Access Compliance Report

Public Rights-of-Way

Intersection ID: 44836	Main Street: PARKDALE_DR	Cross Street: THRIFTWOOD_DR	Location: S
ADA ID: DE6955B2AB6D	Ramp Type: Perp	Initial Pass/Fail: Fail	Overall Compliance: No
		Severity Score: 12.5

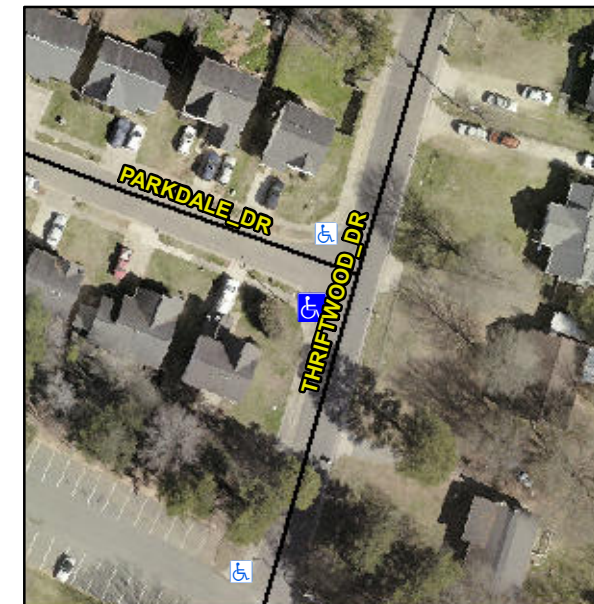
Not Found, R304.5.3

Compliance	Description	Data	Compliance	Description	Data
N/A	Ramp Length (in)	50.0	Yes	Ramp Slope (%)	7.2
Yes	Ramp Width (in)	50.0	No	Ramp XSlope (%)	5.4
N/A	Flare Type LT	N/A	N/A	Flare Type RT	N/A
N/A	Flare Slope LT (%)	N/A	N/A	Flare Slope RT (%)	N/A
N/A	Flare Traversable LT?	N/A	N/A	Flare Traversable RT?	N/A
N/A	Landing Length (in)	N/A	N/A	DWS Provided?	N/A
N/A	Landing Width (in)	N/A	N/A	DWS Contrast?	N/A
N/A	Landing Slope (%)	N/A	N/A	DWS Length (in)	N/A
N/A	Landing X Slope (%)	N/A	N/A	DWS Full Width?	N/A
N/A	Landing Curb? (Y/N)	N/A	N/A	DWS Offset (in)	N/A
N/A	Shared Landing?	N/A			
N/A	Gutter Ponding?	N/A	N/A	Gutter Slope (%)	N/A
N/A	Gutter Lip Ht (in)	0.5	N/A	Gutter X Slope (%)	N/A
N/A	Painted X Walk1?	No	N/A	Painted X Walk2?	N/A
	X Walk 1 Direction	To NE		X Walk 2 Direction	N/A
N/A	X Walk 1 Width (in)	N/A	N/A	X Walk 2 Width (in)	N/A
	X Walk 1 Slope (%)	5.2		X Walk 2 Slope (%)	N/A
	X Walk 1 X Slope (%)	1.0		X Walk 2 X Slope (%)	N/A

Remove & Replace Entire Ramp.
